Maine Yankee

Subject: Proposed Change No. 217: License and Technical Specifications

PROPOSED CHANGE NO. 217

DESCRIPTION AND EVALUATION OF CHANGES

Figure 4.1-1 (DELETED)

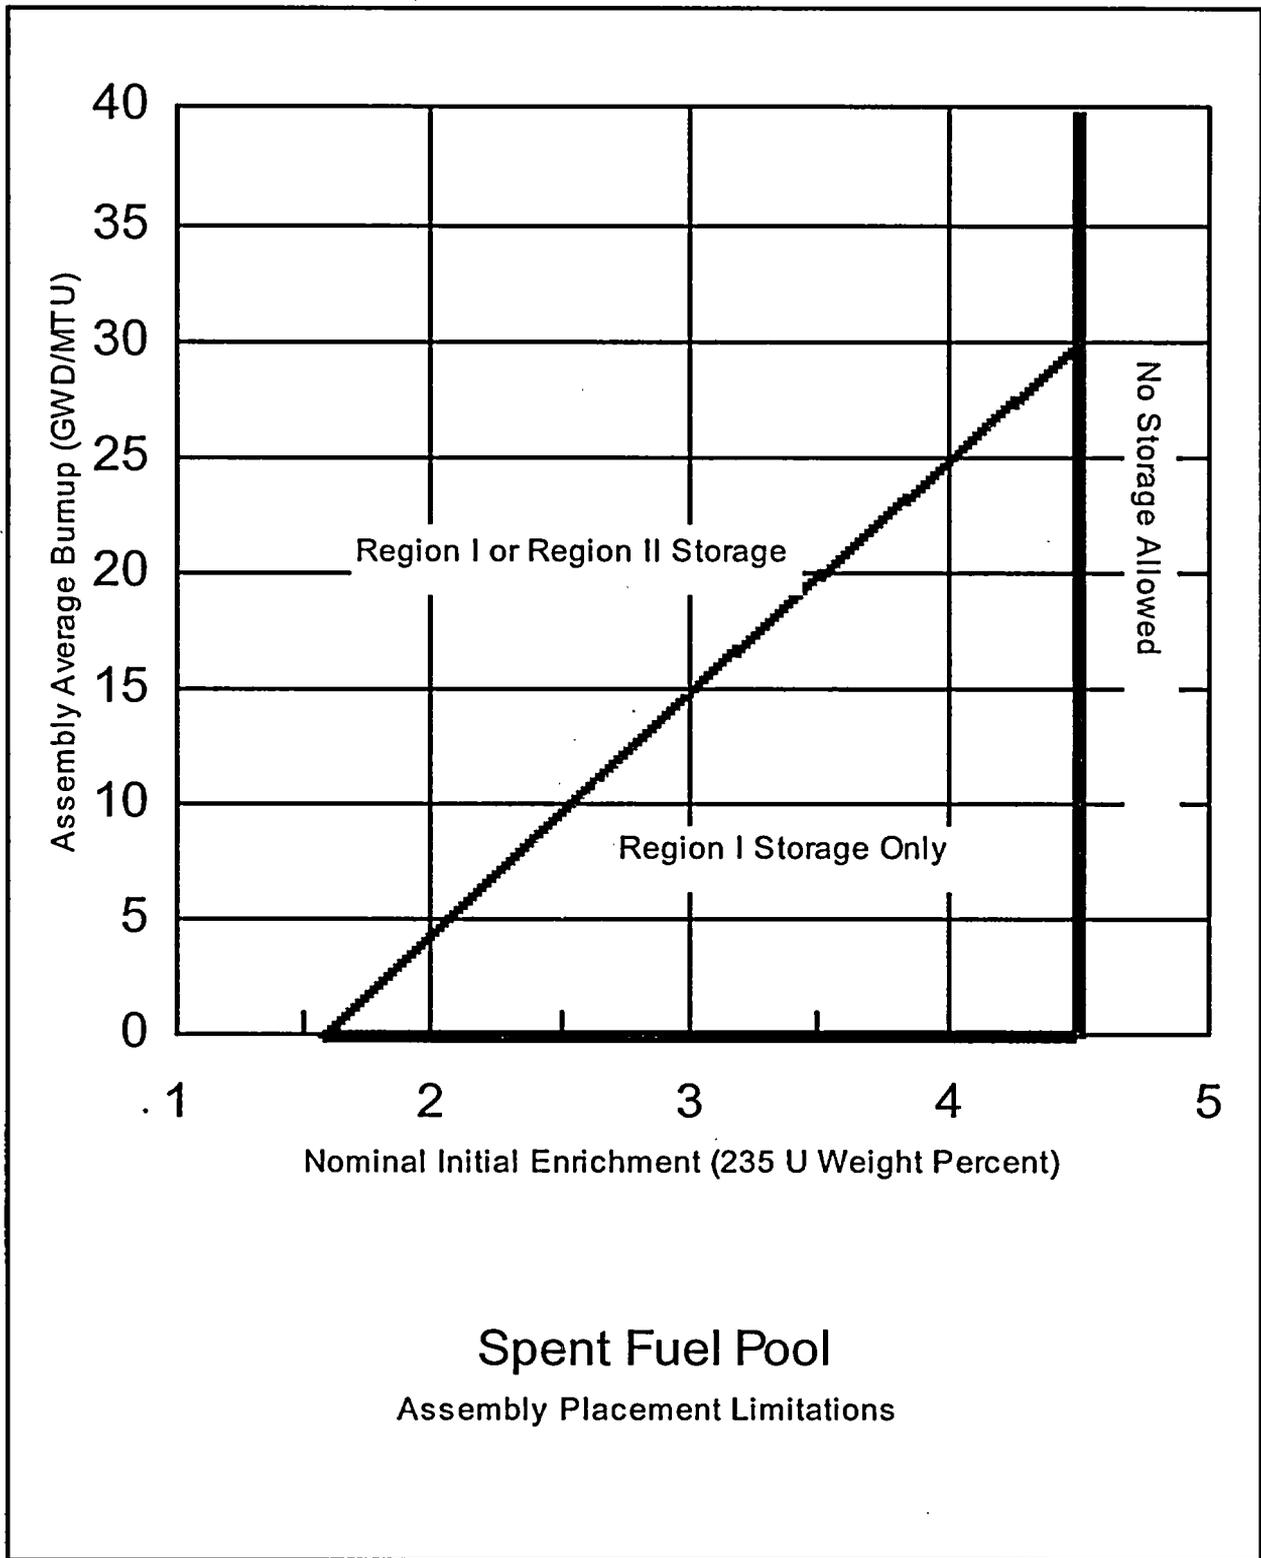
Deletion of Section 4.2 and associated Figure 4.1-1, Spent Fuel Pool Assembly Placement Limitations is being proposed since this section only applied during the storage of irradiated fuel in the fuel storage pool. Fuel storage design features that apply to irradiated fuel stored in dry casks at the ISFSI are contained in the NAC UMS Technical Specification.
